UNITED STATES PATENT AND TRADEMARK OFFICE

| APPLICATION NO. | FILING DATE | FIRST NAMED INVENTOR | ATTORNEY DOCKET NO. | CONFIRMATION NO. |
|-----------------|-------------|----------------------|---------------------|------------------|
| 10/724,135 | 12/01/2003 | Hermann Ruckerbauer | INF-117 | 1211 |

Office Action Summary

DETAILED ACTION

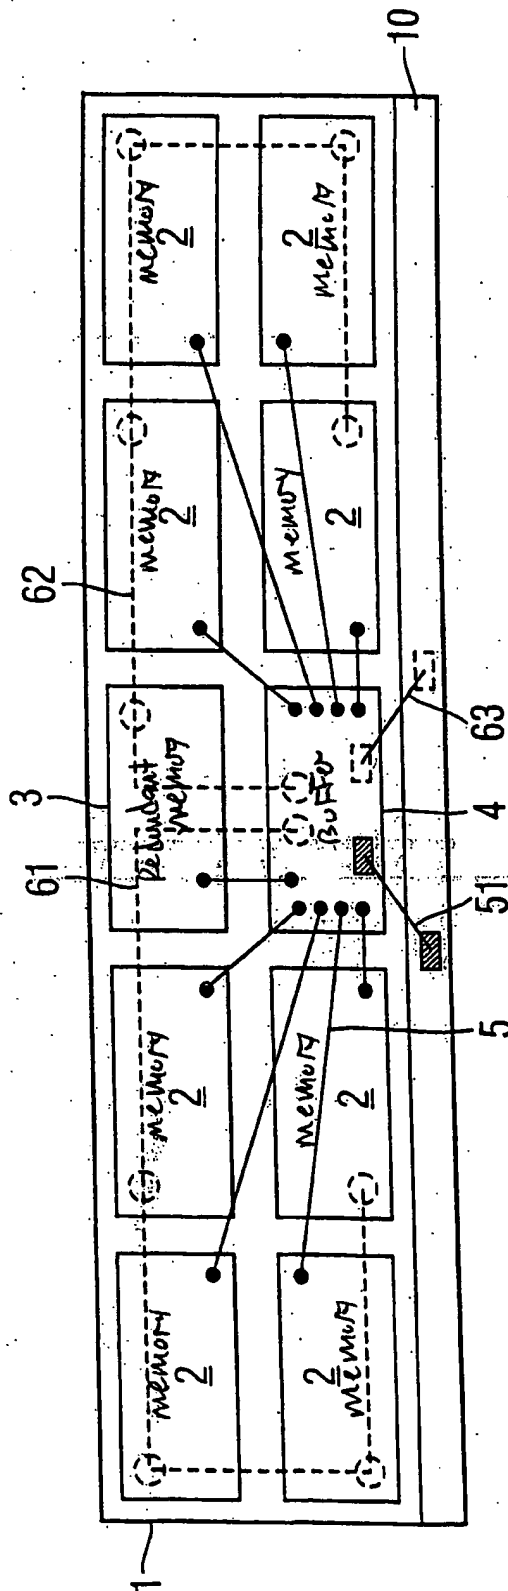
The replacement drawings were received on 9/11/06. These drawings are unacceptable. Although applicant has labeled some of the elements in the replacement sheets, there are some numbered elements that are not labeled on the replacement drawing. Examples: Figure 1 – elements 1, 5, 3 and/or 61 (it is unclear which element the redundant memory is labeling) 62, and 63. The same part numbers are not labeled throughout the remainder of the figures. The drawings are objected to because descriptive labels other than numerical are needed for figures 1-5. See 37 CFR 1.84(o). A proposed drawing correction or corrected drawings are required in reply to the Office action to avoid abandonment of the application. The objection to the drawings will not be held in abeyance.

Figures 1 and 2 should be designated by a legend such as --Prior Art-- because only that which is old is illustrated. See MPEP § 608.02(g). Corrected drawings in compliance with 37 CFR 1.121(d) are required in reply to the Office action to avoid abandonment of the application. The replacement sheet(s) should be labeled "Replacement Sheet" in the page header (as per 37 CFR 1.84(c)) so as not to obstruct any portion of the drawing figures. If the changes are not accepted by the examiner, the

As per claim 2, AAPA teach each of the buffer and error checking modules is connected to an even number of data memory devices for storing the data (see Figure 1).

As per claim 3, AAPA teach the data memory devices are arranged symmetrically with respect to the buffer and error checking module (see Figure 1).
